For Two Stage Series Turbos as used on Renault R9M Gen2  
1.6 litre Euro 5 & Euro 6b engines for Trafic/Vivaro/NV300 vehicles

## IMPORTANT REPLACEMENT INFORMATION FOR HP AND LP TURBOS

Bulletin Revision Level	Date	Detail of changes:
B	18/02/2020	Corrected graphics to show exact turbos (pages 5 & 6) Corrected number of studs required and corrected gasket graphic (page 8) Corrected Gasket and Stud Kit part number (pages 3 & 8) Updated Euro emissions spec (page 1)

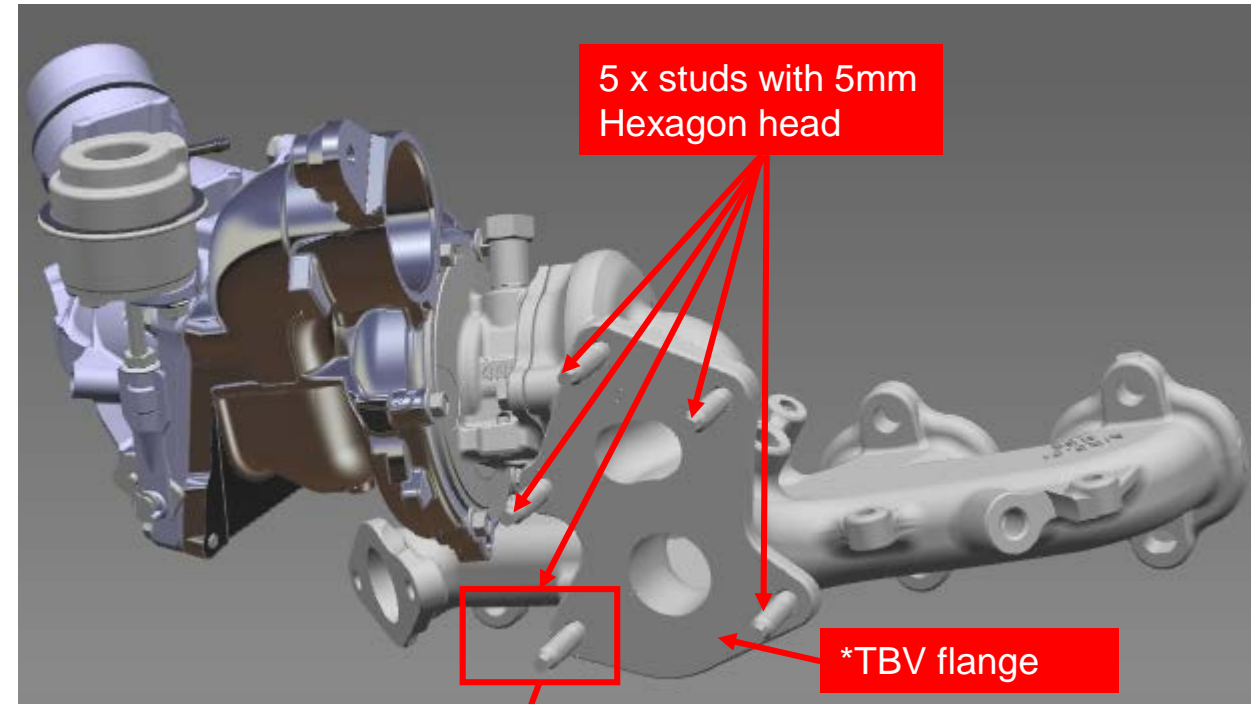
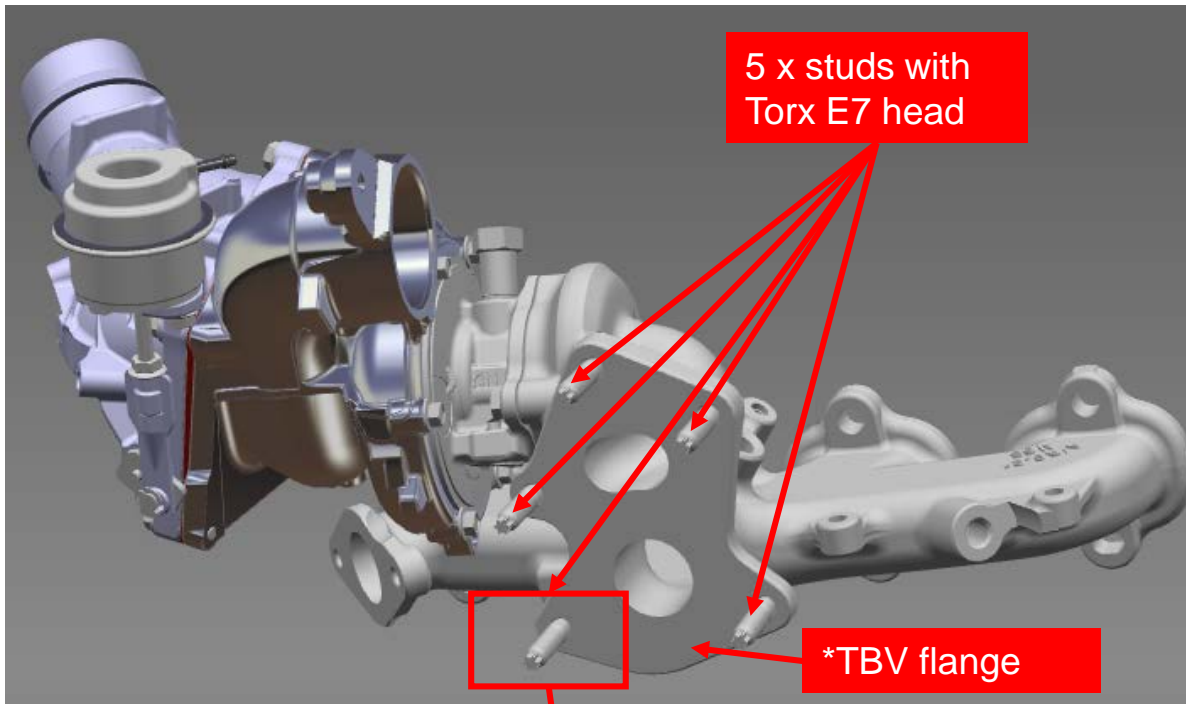
- Summary of changes from 821942-0011 to 883861-0001
  - Garrett internal - change of supplier for component only – no difference in turbocharger fit or performance
  - 883861-0001 is a Direct Service Replacement for 821942-0011

**When using 883861-0001 to replace 821942-0007, -0008 or -0010 the important notes on page 3 apply.**

Configuration of HP Turbos with manifold:  
821943-0002 with Torx E7 studs

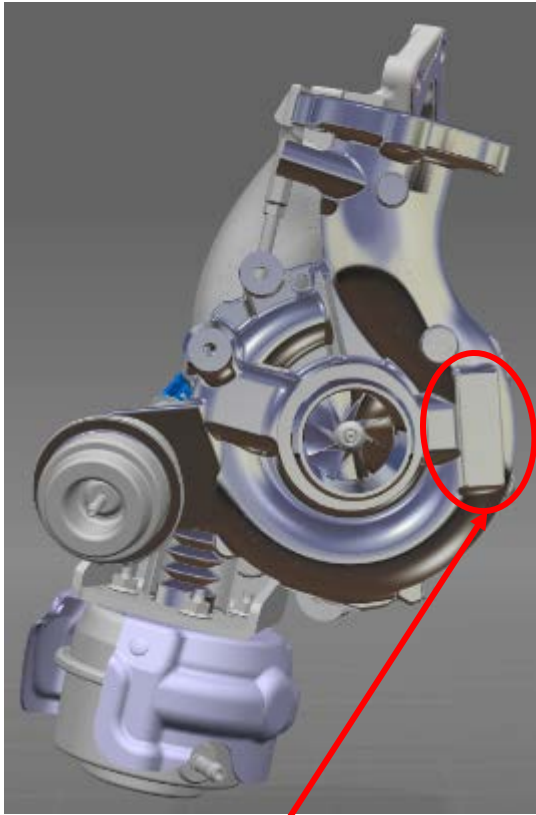
821943-0003 with Hexagon head studs

Old HP Turbo 821943-0002

New HP Turbo 821943-0003

Configuration of LP Turbos:  
821942- 0007, -0009, -0010 with old turbine housing material  
821942-0011 & 883861-0001 with new turbine housing material

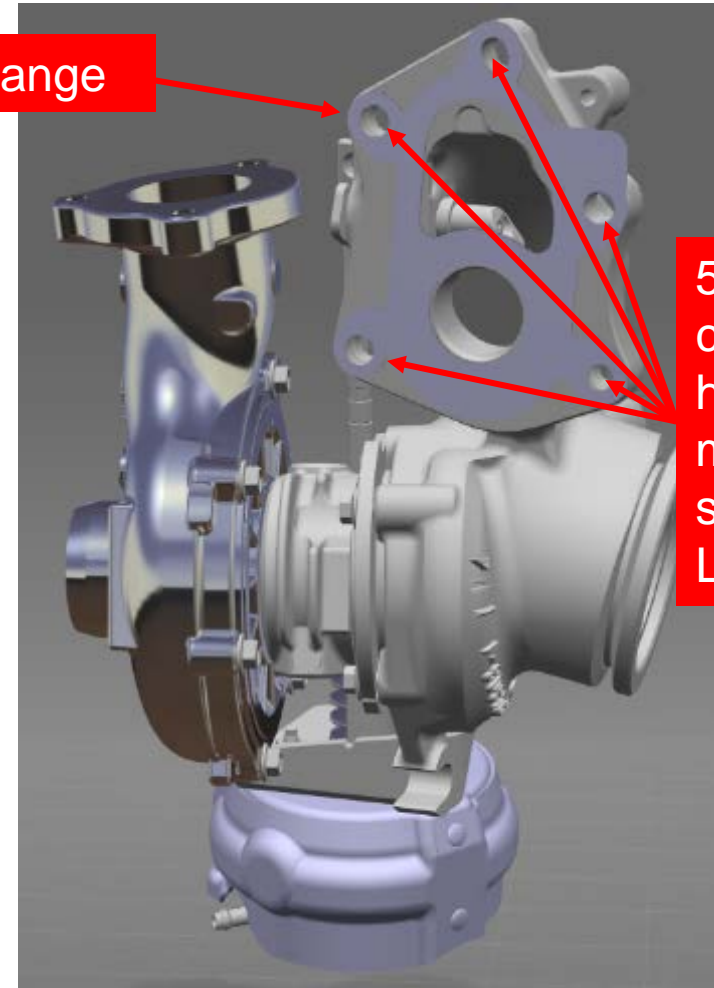
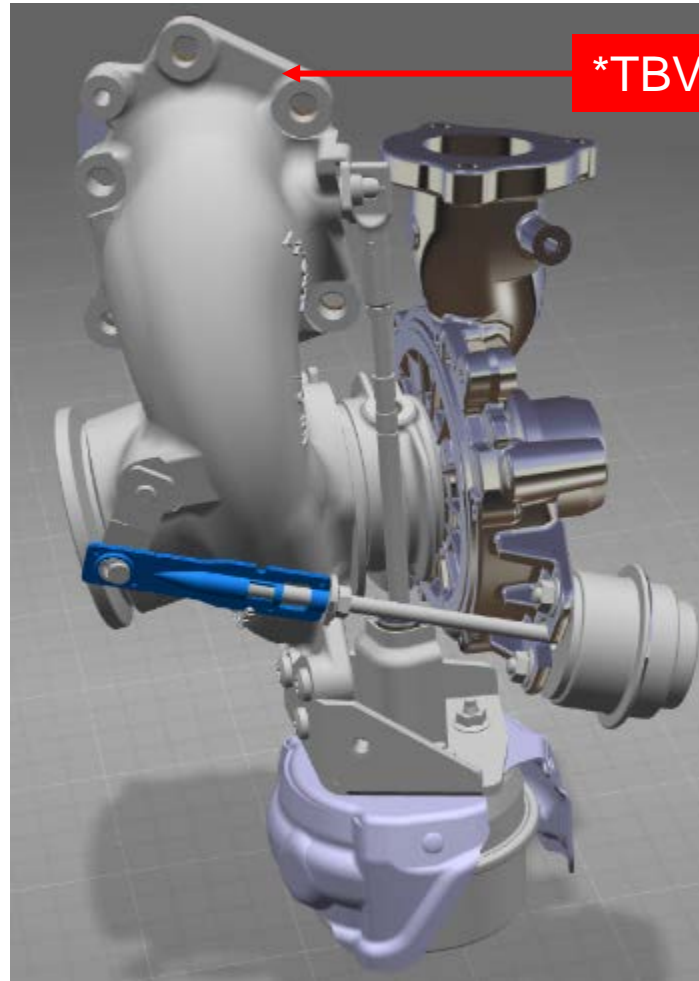
**Note: all LP turbos look the same, so check part number from nameplate on compressor housing or check casting marks as shown on page 7**

# Identification of LP Turbos:

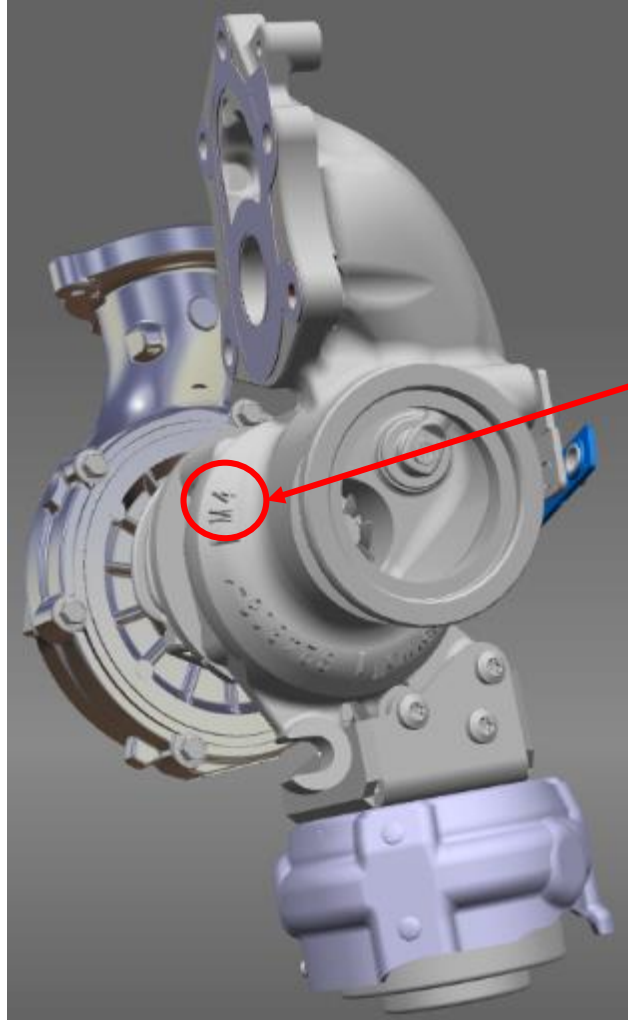
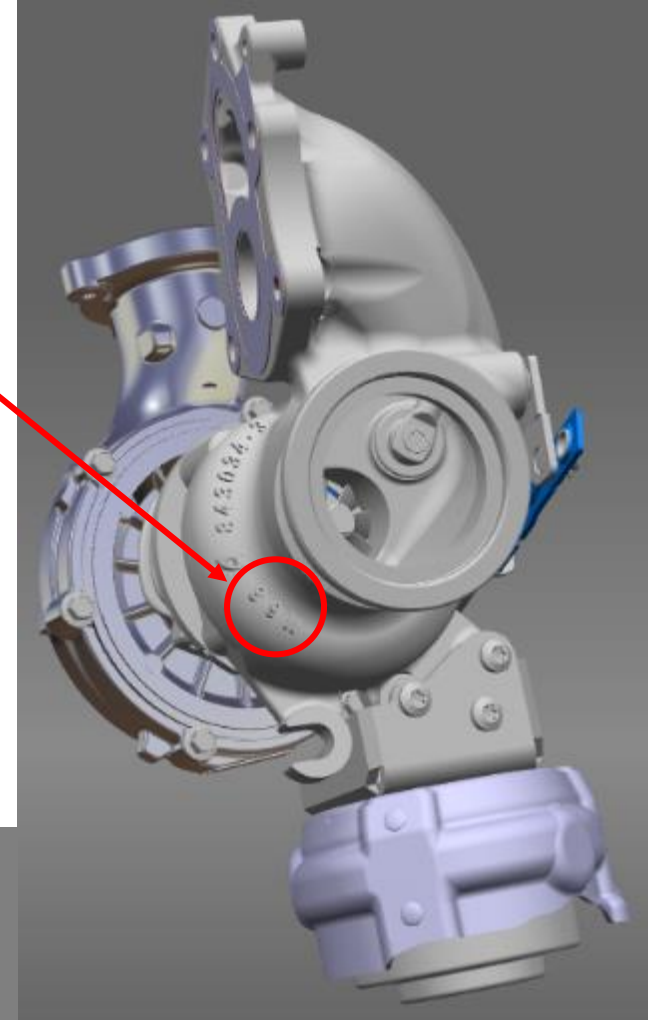
Left: 821942- 0007, -0009, -0010 with old turbine housing material

**Turbine Housing  
casting mark for  
OLD material is  
"M4"**

**Turbine Housing  
casting mark for  
NEW material is  
"M68"**

821942-0011 & 883861-0001  
with new turbine housing  
material
